Dominion Data Center – Table in 2023 Load Forecast (B9)

Load Analysis Subcommittee
June 26, 2023

Dominion Load Adjustments

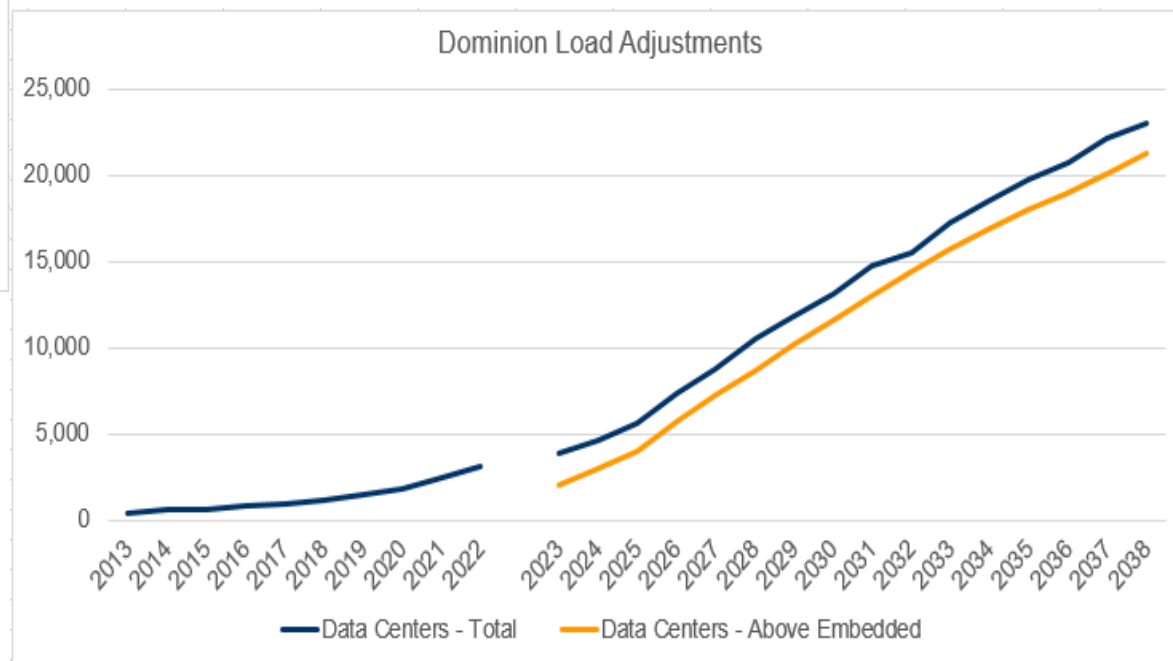
- Prior to the 2023 Load Forecast Report Table B9 showed the amount of load adjustment in excess of the embedded amount of adjustment already in history.
- In the 2023 Load Forecast PJM showed values for Dominion (“DOM”) that reflected the total amount of data center load.
- Updated Table B9 now reflects the amount that the forecast is increased considering the adjustment above what would have been embedded.
